SAN FRANCISCO PLANNING DEPARTMENT

2009.1170DDD

Memo to the Planning Commission

37-39 Lloyd Street (aka 35 Lloyd Street)

"Little House Committee" Floor Plans

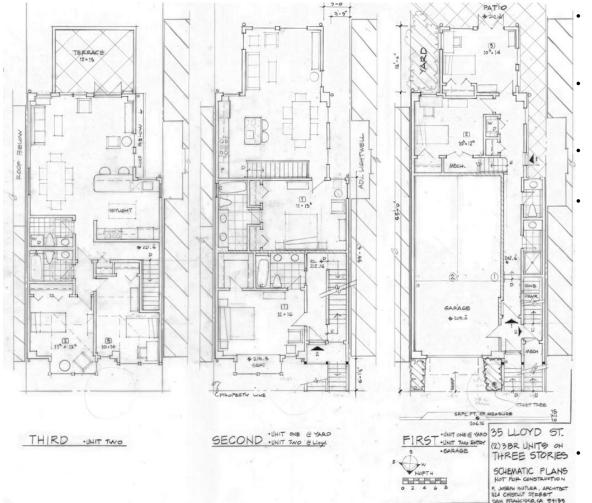
- Schematic Plans Do NOT Meet Construction Requirements:
- Stair Layouts and Runs Inadequate: Not Enough Steps for Interior and Exterior Access
- Bathroom Rooms Not Drawn to Scale
- Building Codes NOT Satisfied
 - Illegal Window Size for All Bedrooms:
 - Particularly, Master Bedroom in Unit 1
- Height of Entry for Unit 1: Inaccessible Headroom
- Fire Codes NOT Satisfied
- Egress Requirements
- Length of Entry to Living Quarters for Unit 1
- Units Not Compatible for Family Housing
 - Outdoor Space
 - Convoluted Access for Unit 1
 - Inadequate Space for Unit 2
 - Bathrooms
 - Split Bath for Guest Bedrooms in Unit 1
 - No Half Bath at Living Room Level for Unit 1
 - Toilet at Inappropriate Location for Master Bath in Unit 2
 - Bedrooms
 - Illegal Master Bedroom in Unit 1
 - Non-Functional Bedroom in Unit 2: Really Den
 - Bedrooms Cannot Accommodate Queen-sized Beds
 Kitchops
 - Kitchens

• Not Drawn to Scale to Accommodate Appliances Back Façade Opens to Light Court Rather Than Mid-Block Open Space: Greatly Limiting Light and Air

PREVIOUS REVISIONS MADE AT REQUEST OF DR APPLICANTS, DRAWINGS DATED 9.8.10

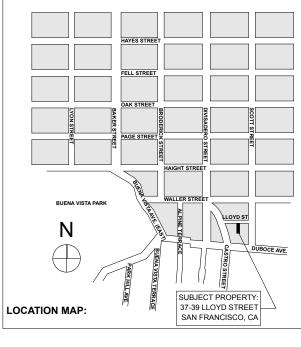
1. REDUCED HEIGHT OF STAIR PENTHOUSE TO MINIMUM CELING HEIGHT REQUIRED BY CALIFORNIA BUILDING CODE

2. REDUCED DOORS IN STAIR PENTHOUSE AT ROOF DECK TO 6'-8" TALL

3. SET BACK NORTHERN GUARDRAIL AT ROOF DECK 3-FEET

4. OUTLINE OF STAIR PENTHOUSE AND ROOF DECK GUARDRAILS ARE SHOWN IN ELEVATIONS

5. ALL GUARDRAILS AT THE ROOF DECK CHANGED TO GLASS WITH METAL SUPPORT POSTS

6. LIGHT WELL LENGTH INCREASED TO 10.7' WHICH IS 75% OF THE ADJACENT LIGHT WELL

FURTHER REVISIONS MADE FOR THE DR APPLICANTS, DRAWINGS DATED 1.3.11

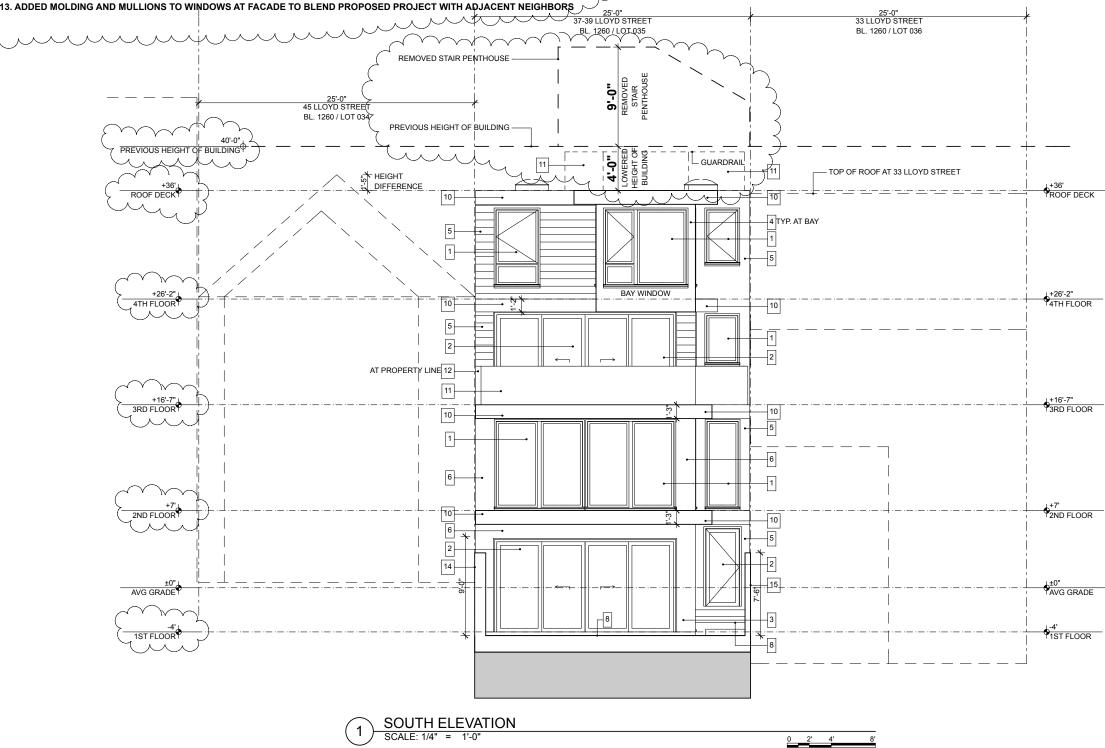
1. REMOVED STAIR PENTHOUSE

2. REDUCED OVERALL BUILDING HEIGHT TO 36-FEET FROM PREVIOUS HEIGHT OF 40-FEET AND 9'-0" FOR STAIR PENTHOUSE (40' ALLOWED BY ZONING)

- 3. REDUCED HEIGHT OF BUILDING FACADE AT STREET TO 26'-2" FROM PREVIOUS HEIGHT OF 29'-2" (40' ALLOWED BY ZONING)
- 4. STAIRS TO ROOF CHANGED TO EXTERIOR STAIRS INSET INTO 4TH FLOOR LIVING SPACE

- 5. ADDED GABLED CORNICES TO THE FACADE (NORTH ELEVATION) TO BLEND PROPOSED PROJECT WITH ADJACENT NEIGHBORS
- 6. REDUCED HEIGHT OF INTERIOR ROOMS TO 8'-5" FROM 9'-0" (FLOOR TO CEILING HEIGHT) IN ORDER TO LOWER THE BUILDING HEIGHT

- 7. EXCAVATION OF AN ADDITIONAL 18" (FOR A TOTAL OF 4' OF EXCAVATION FROM AVERAGE GRADE) IN ORDER TO LOWER THE BUILDING HEIGHT
- 8. REDUCED DEPTH OF FLOOR/CEILING FRAMING IN ORDER TO LOWER THE BUILDING HEIGHT

- 9. REMOVED 2 WINDOWS ON THE EAST ELEVATION
- 10. ADDED OBSCURED / FROSTED GLAZING TO EAST ELEVATION
- 11. ADDED ADDITIONAL LANDSCAPING AT FRONT YARD SETBACK

- 12. ADDED 1 BEDROOM TO LOWER UNIT, THEREFORE BUILDING CONTAINS TWO 3-BEDROOM UNITS
- 13. ADDED MOLDING AND MULLIONS TO WINDOWS AT FACADE TO BLEND PROPOSED PROJECT WITH ADJACENT NEIGHBORS 🗩

Light Well Impact

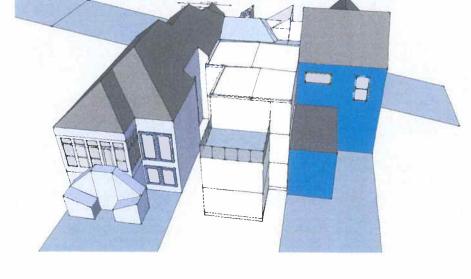
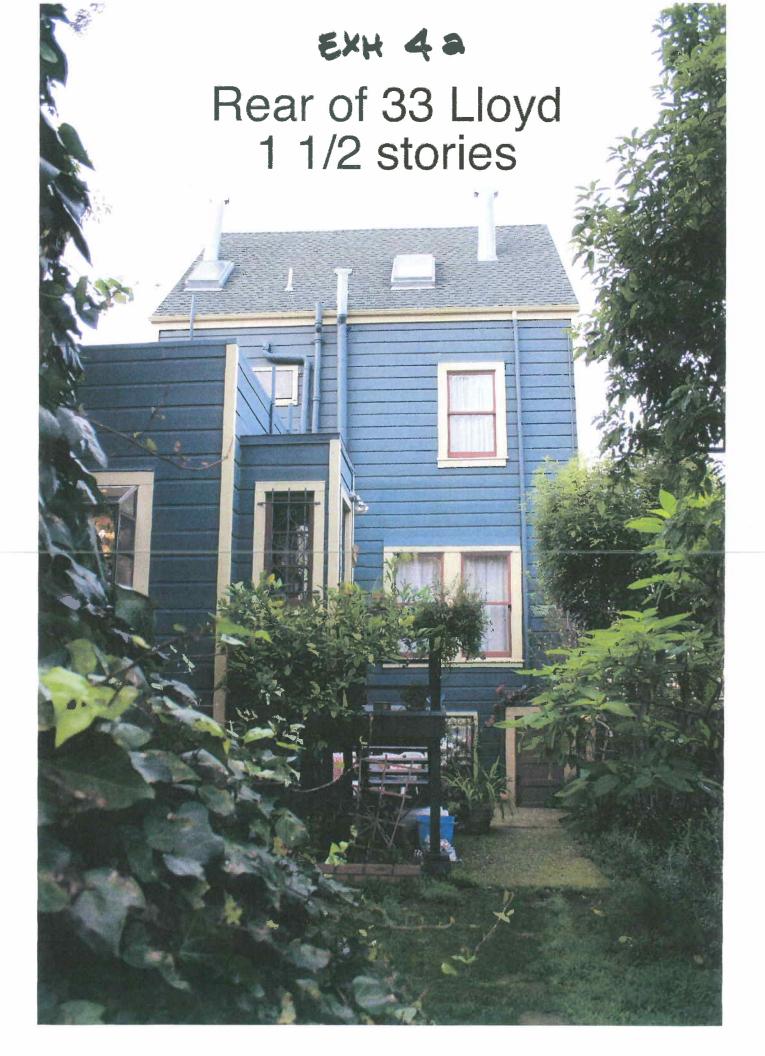
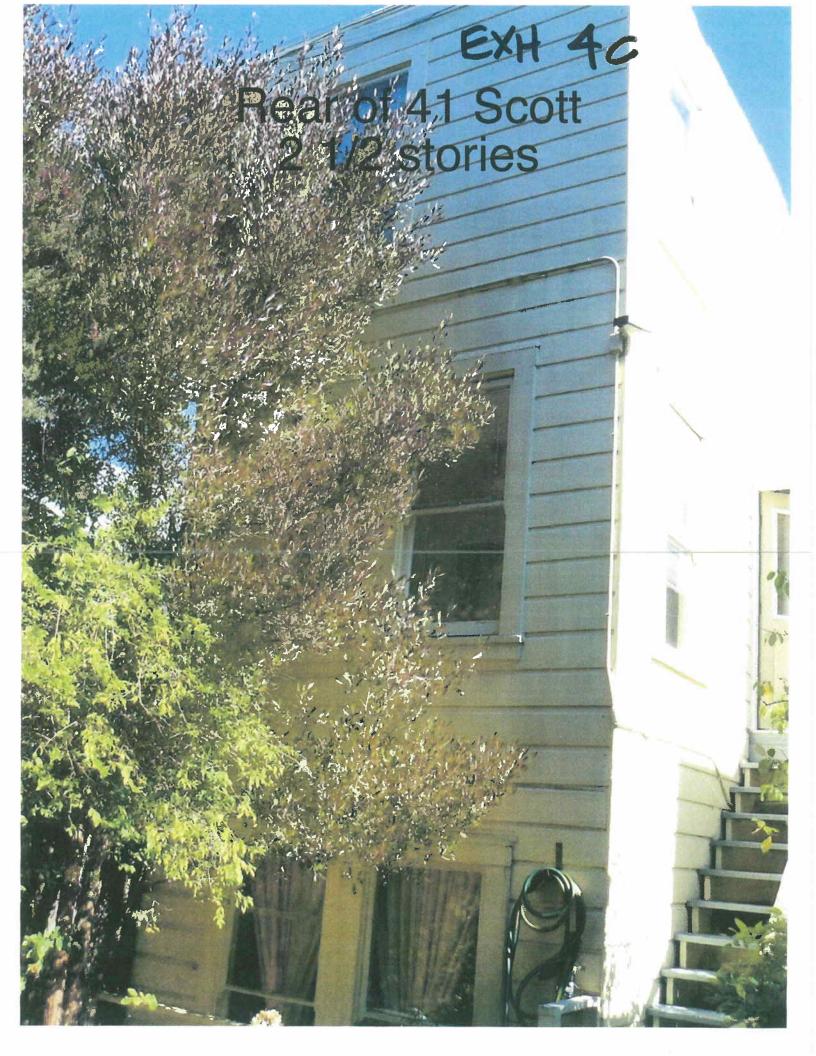
Absent a Commission suggested study between the two sides' architects of three story schemes that might not need a Variance, the neighbors produced two schemes **as examples** of how two three bedroom units could be designed on three levels of construction **(EXH 2)**. Without the 5 x 12 space to the west of the pop-out (on two floors) that requires a Variance, the light well for 45 LLoyd (Volkert) can be made to not only match in size, but combined with the 5 foot setback for the pop-out, Volkert's light well would be open on the south side to let maximum sunlight, including limited direct sunlight at different times throughout the year **(EXH 3)**.

The elimination of the fourth floor at the rear of the building proposed would greatly increase the light and air that gets to neighboring buildings, especially 33 (DeNunzio) and 45 Lloyd (Volkert), adjacent. The three stories at the rear is more consistent with 41 Scott (Telthorst) at 2 1/2 stories, 33 Lloyd (Denunzio) at 1 1/2 stories, and 45 Lloyd (Volkert) at 2 stories **(EXH 4a,b,c,d e)**. Being the last lot developed on this block, a careful response to the existing homes here should have been the basic premise that guided this design from the start.
